Field Memo

Date Submitted:	01/06/2025	**Field Memo #:**	**055**
Contract Name:	RapidRide J Line BRT (Re-Bid)	**PW #:**	2023-002
Contractor:	Jansen, Inc.	**Fed Aid #:**	WA-2024-012-00 WA-2024-013-00 WA-2023-070-00

Subject: Environmental Field Memo – Weekly Environmental Site Walk Action Items

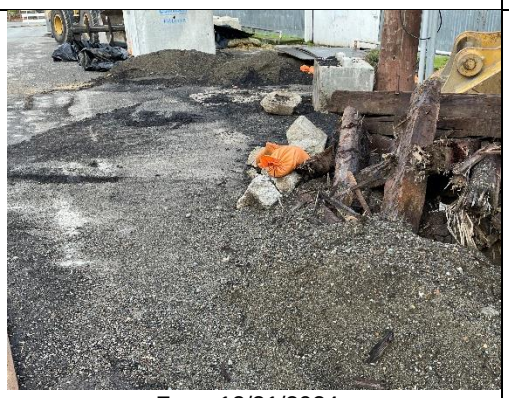
Issue: Stockpile left unprotected at Eastlake and Garfield staging area.

Recommendations: Make sure excavated spoils are covered particularly during a rain event or after left uncovered and worked for no more then 2 days. Stabilize and protect unworked soil securely and provide sediment control measures as required in SWPPP and Standard Specification Section 8-01.3(1).

Reference:
NPDES S4. D.5. Stabilize Soils
"The Permittee must stabilize exposed and unworked soils by application of effective BMPs that prevent erosion."

Spill 2.1 Element 7 Stabilize Soils
"In the event stockpiling of soils occurs, (if a truck is not immediately available to take waste rubble, less than 24 hours while waiting for truck load out) stockpiles will be placed on construction geotextile fabric, covered with plastic and surrounded by sandbags per BMP E1.20 as necessary"
